**ZONING MAP CHANGE  
STAFF REPORT**

**City Council Meeting Date:**  
September 15, 2020

**Request:** From: "A-5" One Family, "F" General Commercial, and PD 1222  
To: PD/C Planned Development for all uses in "C" Medium Density Multifamily plus boutique hotel with development regulations for height, driveway location, building orientation, façade variation, setbacks, fencing, open space, and signage, with a waiver to the MFD multifamily submittal; site plan included

**"PD-C / HOTEL" SITE PLAN**  
**BOWIE HOUSE HOTEL**  
1.83 ACRES  
LOTS 16 - 24, BLOCK 1  
MATTISSONS ADDITION  
VOL. 310, PG. 47 P.R.T.C.T.  
September 3, 2020

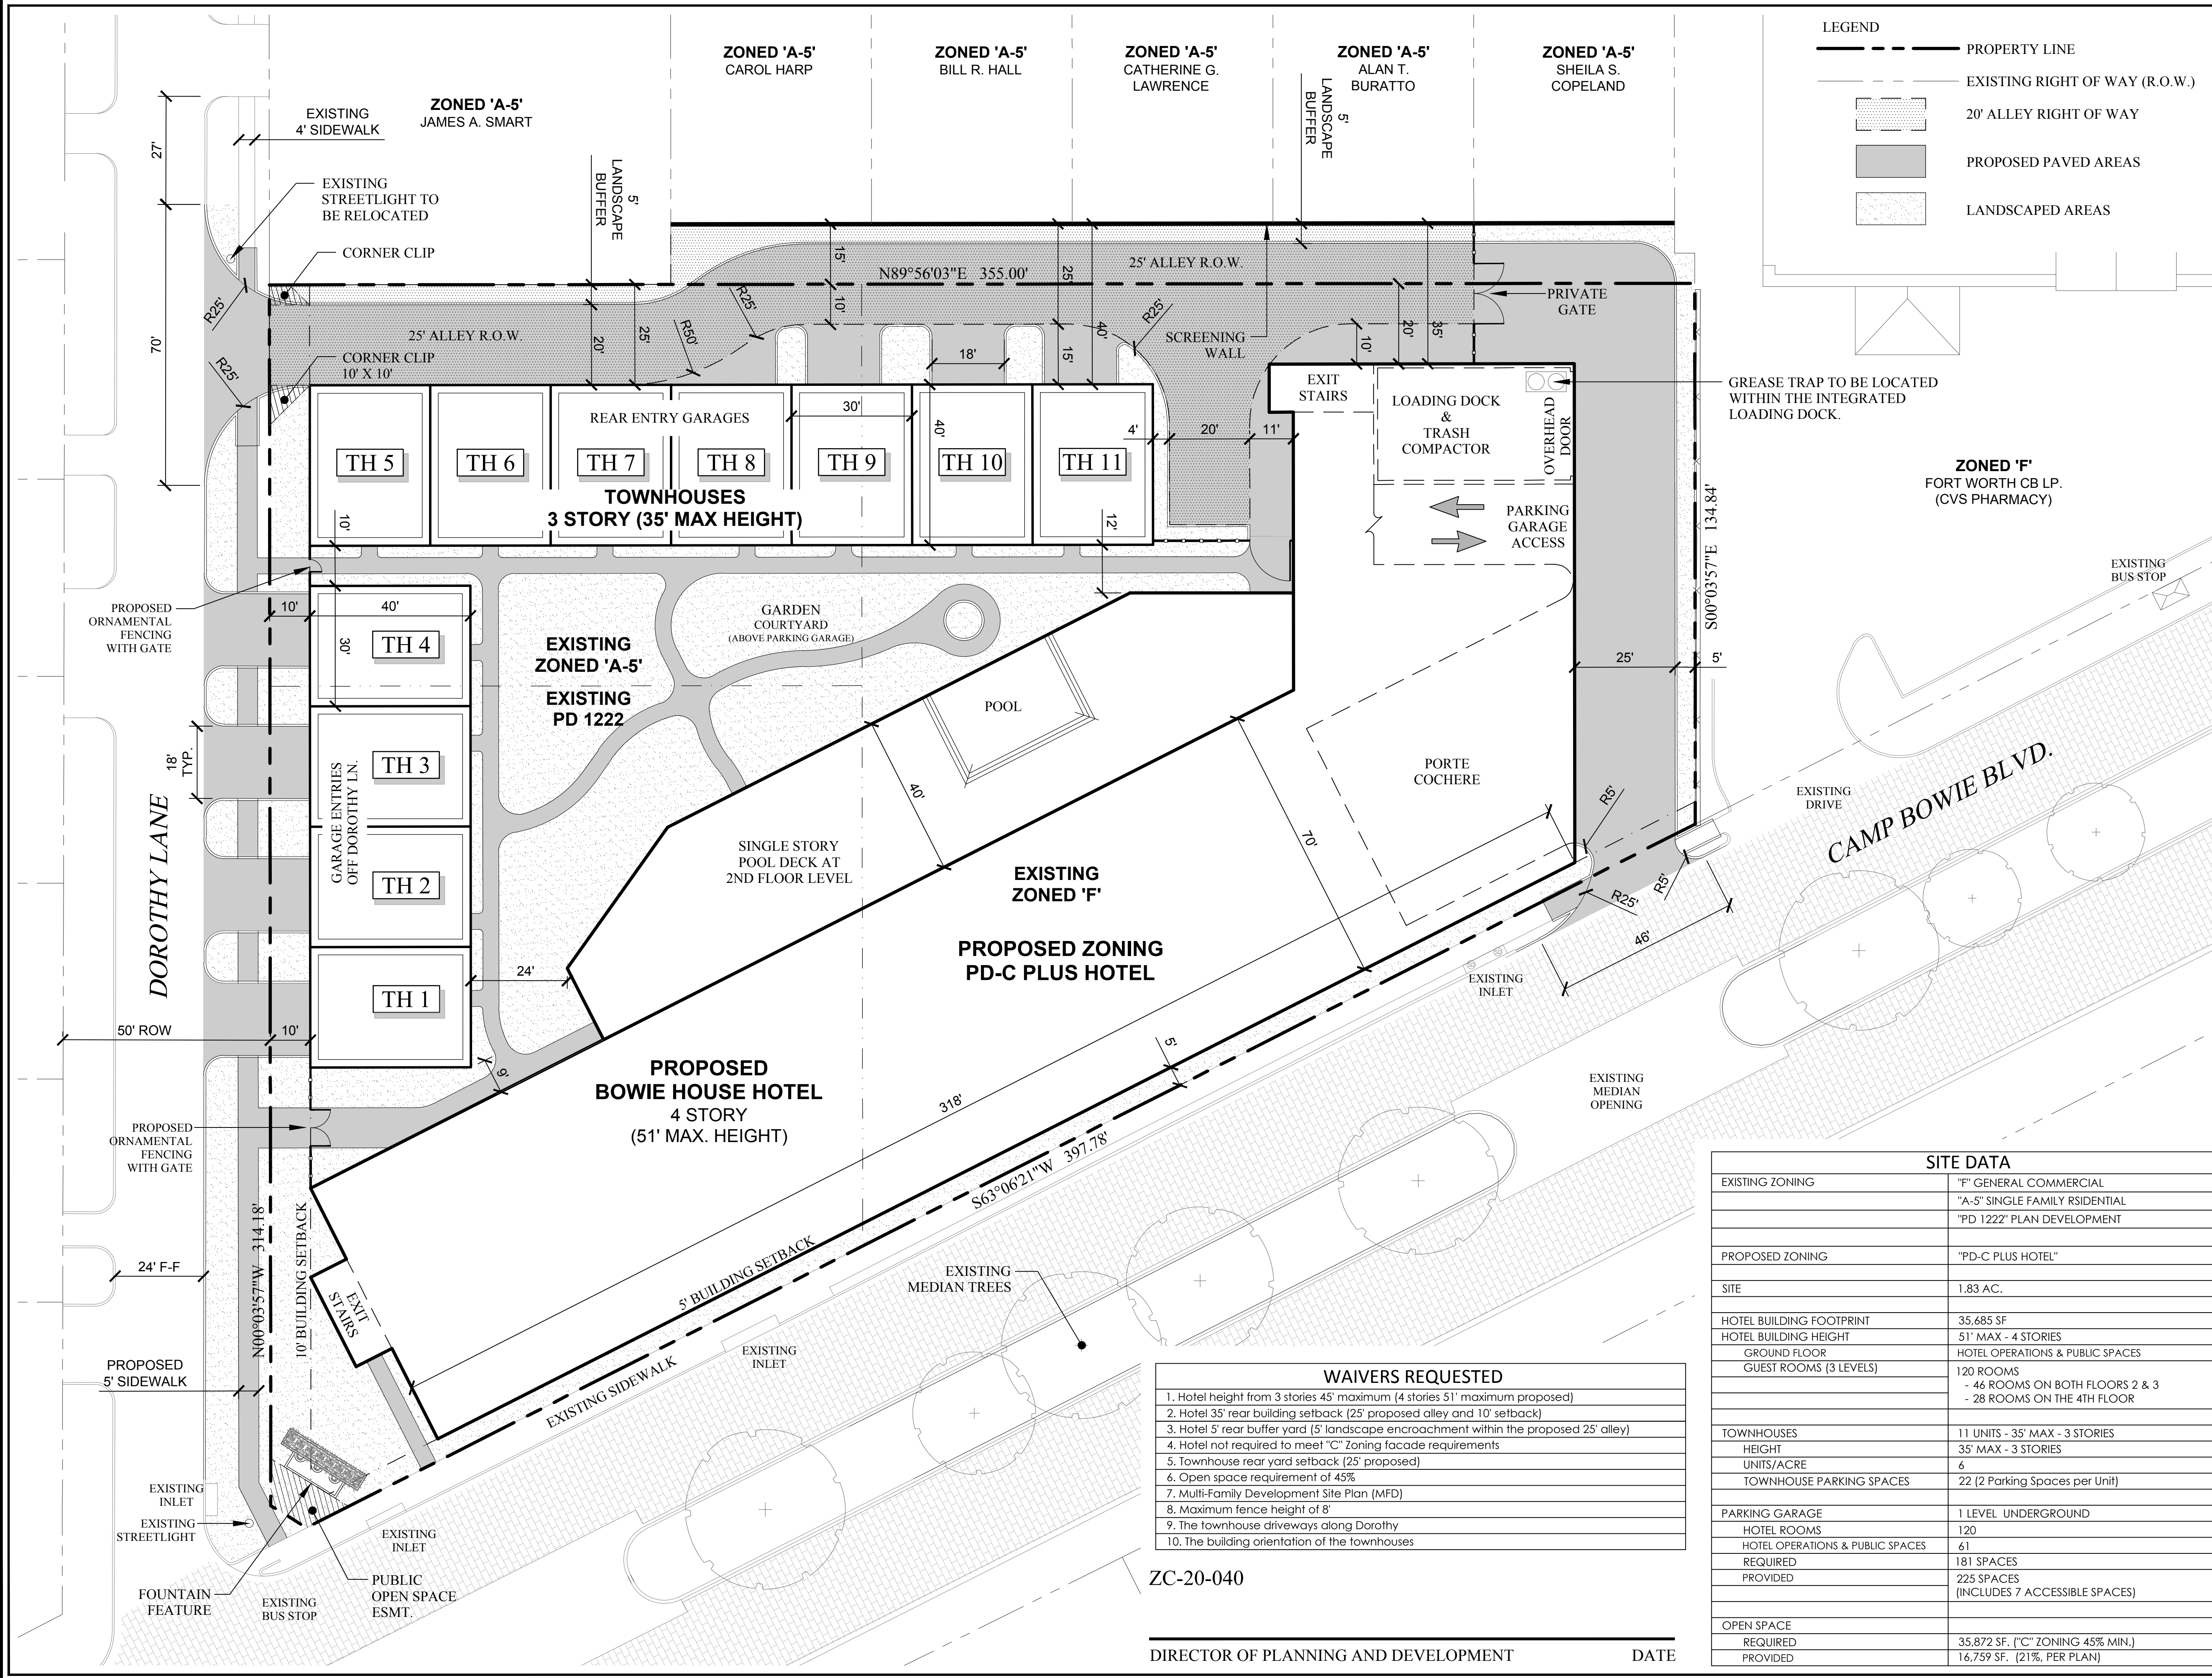
**Site Plan Comments:** The site plan as submitted is not in general compliance with the Zoning Ordinance regulations.

1. Required rear yard setback is 105'; 10'-40" provided. (**waiver required**)
2. Required front yard setback is 20'. Shown is 5' and 10'. (**waiver required**)
3. Maximum height is 36'. Hotel is proposed to be 51'. (**waiver required**)
4. Minimum open space is 45%. Proposed open space is 21% (**waiver required**)
5. A screening fence up to 10' will be built along the northern boundary (**waiver required**)
6. Signage for the hotel will meet commercial signage regulations (**waiver required**)
7. Driveway location between the building and the street (**waiver required**)
8. Long end of the northern townhomes is not parallel to the street. (**waiver required**)
9. The hotel will no be required to meet the façade variations (**waiver required**)
10. MFD submittal is not required (**waiver required**)
